NOTICE OF MEETING

A meeting of the ARGYLL AND BUTE LOCAL REVIEW BODY will be held BY SKYPE on TUESDAY, 8 DECEMBER 2020 at 9:15 AM, which you are requested to attend.

- 1. APOLOGIES FOR ABSENCE
- 2. DECLARATIONS OF INTEREST
- 3. CONSIDER NOTICE OF REVIEW REQUEST: CARDROSS GOLF CLUB, MAIN ROAD, CARDROSS (REF: 20/0012/LRB)
 - (a) Notice of Review and Supporting Documentation (Pages 3 20)
 - (b) Comments from Interested Parties (Pages 21 34)

REFUSAL OF PLANNING PERMISSION FOR INSTALLATION OF ROOF MOUNTED PHOTOVOLTAIC PANELS

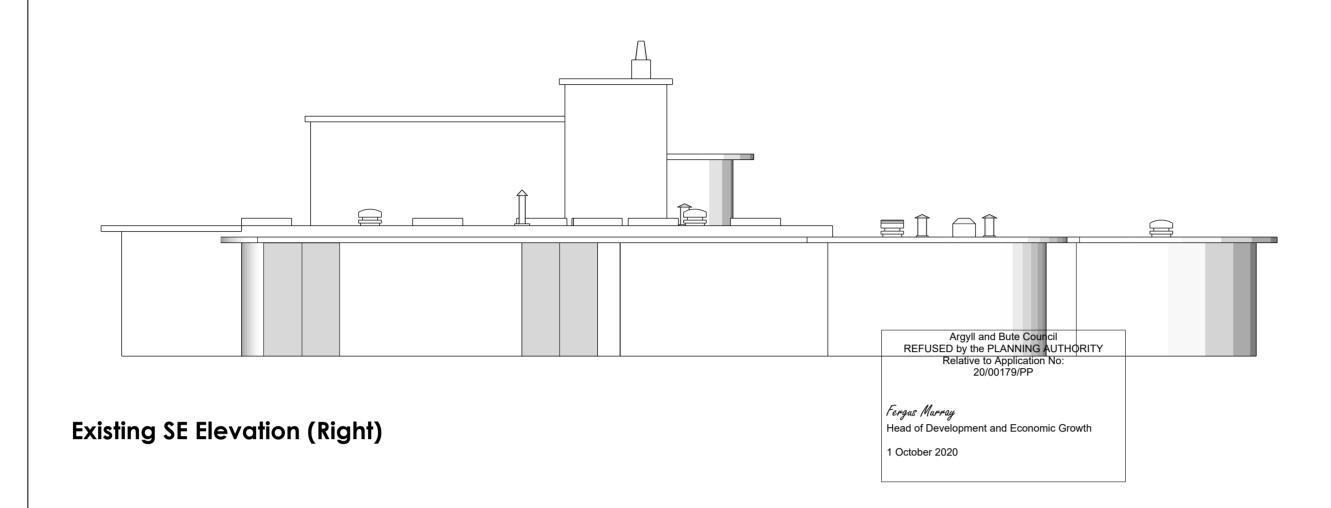
Further to our conversations with the planning office and the original approval of the application from the department, we are very disappointed to hear of the differing opinion from the senior planning officer around the project and its potential visual impact. Engenera had a communication with Howard Young who mentioned during a call that he hadn't looked at the project in great detail which was our first concern that the review process hadn't been given due care and attention. Please see attached the plans demonstrating the actual visual effect of an array of this size is very minimal – especially considering the vast amount of other roof obstructions which sit higher on the roof, than what the proposed solar array would. It was also commented around being able to see the array from a height which again is confusing as from the front of the building that would appear to be impossible and from the back (as the image below shows) is the golf course so I find it hard to understand the councils view.

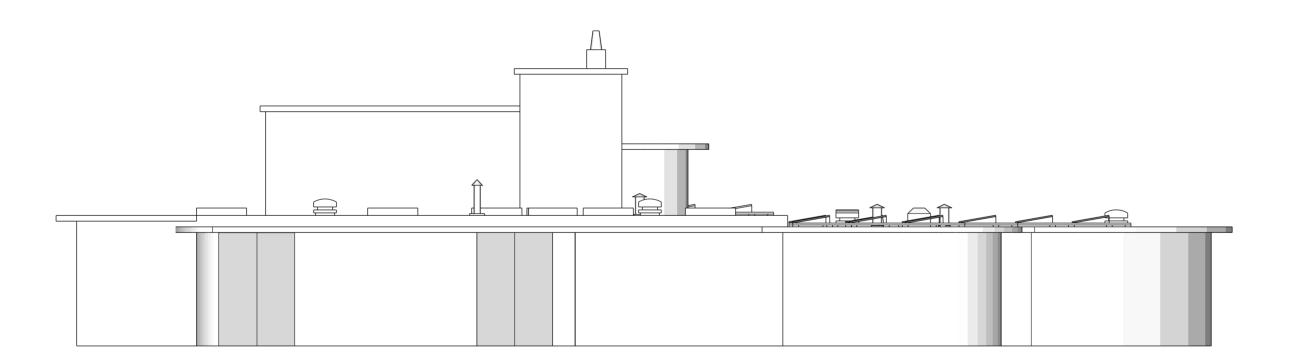
The positive I took from previous correspondence is that there is a compromise to be reached and I assume this refers to promoting micro renewables, which as we know, is very much a policy that local authorities are having to adhere to. Owning and maintaining listed buildings is all well and good, however the associated running costs are detrimental to the financial sustainability of these local organisations (especially in these tough times). As such, we must strike a balance between appearance and installing a system which is large enough to have the desired impact financially. We have looked at every possibility, but the installation would need to be roof mounted to make the project financially beneficial to the course.
